# Review of Vermont Yankee Thermal Discharge Modeling

February 6, 2012

This report provides a review of a report entitled, *Hydrothermal Modeling of the Cooling Water Discharge from the Vermont Yankee Power Plant to the Connecticut River* by Applied Science Associates (ASA 2004). The 2004 hydrothermal modeling report was submitted in support of a 316(a) demonstration for the Vermont Yankee Power Plant. The thermal impact analysis provided in the 2004 demonstration was framed as an incremental update of two previous 316 demonstrations, conducted in 1978 and 1990. As a result, it was necessary to review and briefly summarize the thermal studies associated with the 1978 and 1990 demonstrations in this report.

Figure 3-1. Example of model calibration figures from 2004 report (ASA 2004).

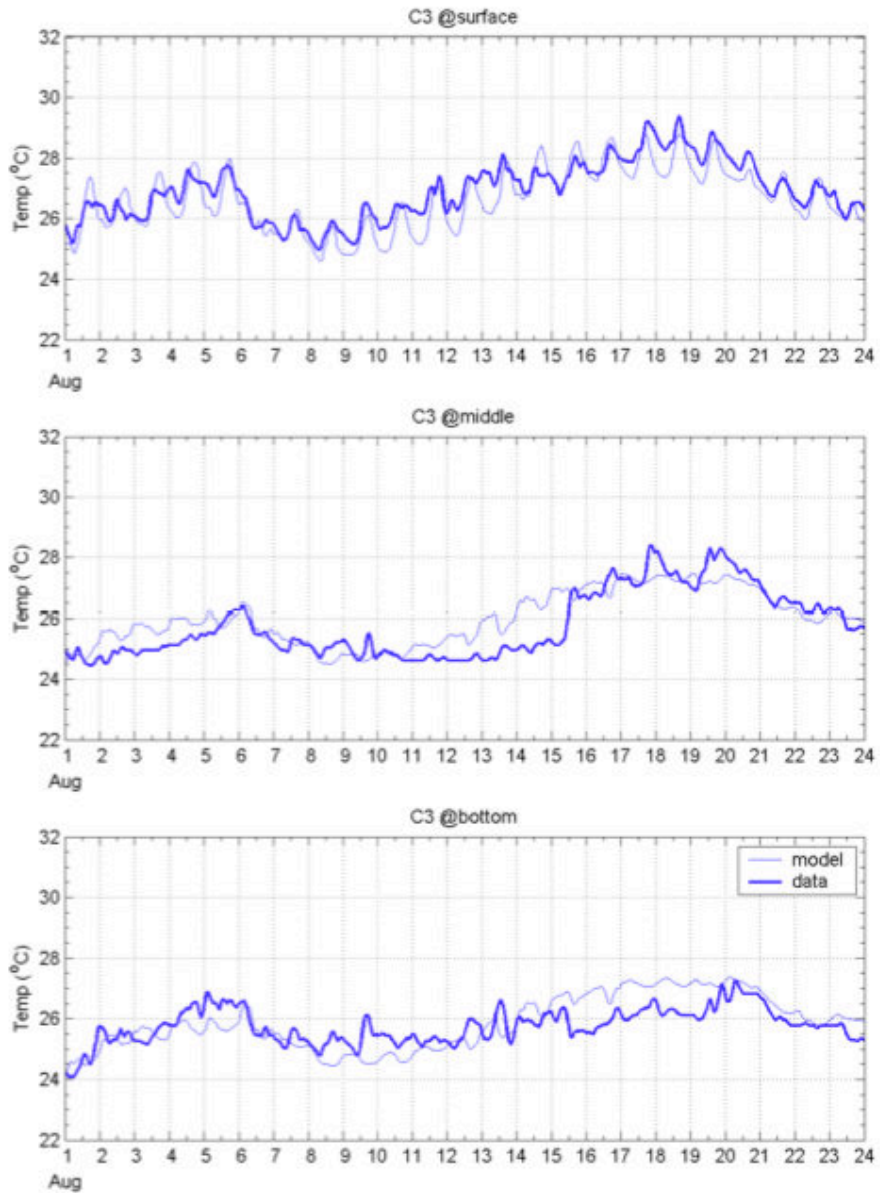
ASA (2004) indicates the model was calibrated to dynamic river conditions over a 24-day period, August 1-24, 2002, “when air temperature was in general warmer than any other month and river temperatures were warmest.” (ASA 2004, p. 32). The model was confirmed during a 15-day period from June 25 to July 9. Time-series plots and statistical summaries of predicted vs. measured temperature data during the two calibration periods are provided in the report. An example plot is included here as Figure 3-1. The report does not indicate the corresponding Vermont Yankee discharge flow rates and temperatures or river flow rates that occurred during the calibration and confirmation time periods (e.g., in a format similar to Figure 2-3 from the 1978 study).

Figure 3-2. Predicted surface temperature from a 2004 model scenario (ASA 2004).

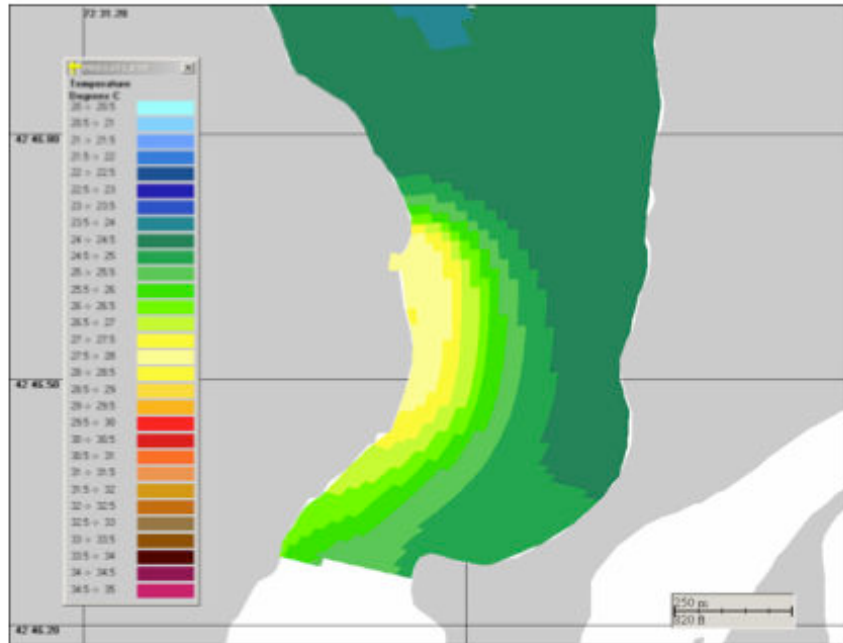
The ASA report did not provide results consistent with those specified in the EPA 316(a) guidance (EPA 1977). Specifically, the ASA report did not provide maps of the thermal discharge plume out to the 1°C isotherm under a variety of conditions. The ASA report also did not provide the areal extent of the thermal plume and the associated conditions (i.e., Vermont Yankee operations, ambient river conditions, and Vernon Dam operations) under a variety of conditions. The ASA report failed to provide a sufficient temperature characterization of the Connecticut River study area.
